Technical Service Information

MAZDA G4A-EL STACKED SHIFTS

Figure 1

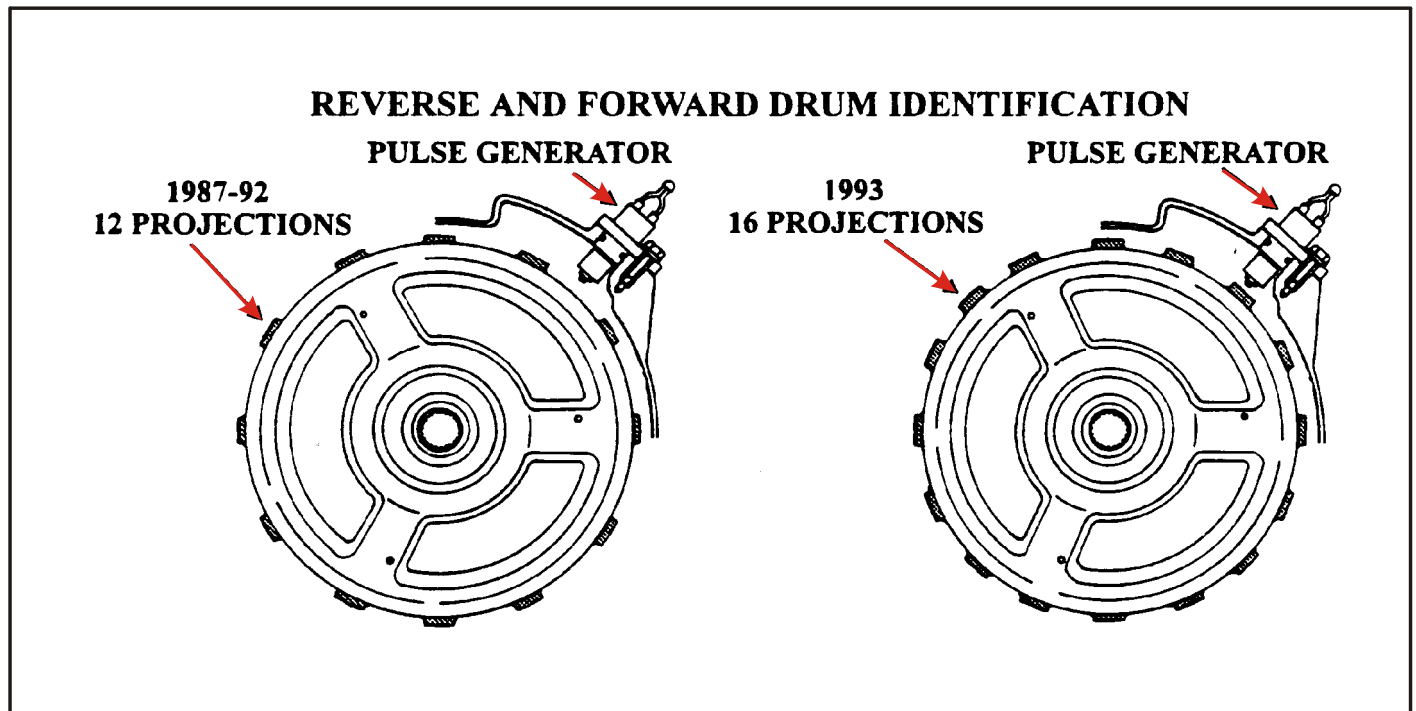
COMPLAINT: Vehicles equipped with G4A-EL transmissions may exhibit early or "Stacked Shift's" with Converter Clutch apply by 20 mph., *after overhaul*, without storing any trouble codes.

CAUSE: The cause may be, a mismatched 1993 Reverse and Forward drum was installed into a 1987-92 vehicle. **REASON:** 1987-92 Reverse and Forward drums have 12 "Projections." 1993 Reverse and Forward drums have 16 "Projections." These "Projections" are picked up by the "Pulse Generator" converting drum or turbine speed into an A.C. current or frequency that is sent to the ECAT computer. When a 16 "Projection" drum is installed into a 1987-1992 vehicle, drum or turbine speed will automatically be faster and may change shift strategy. (See Figure 1).
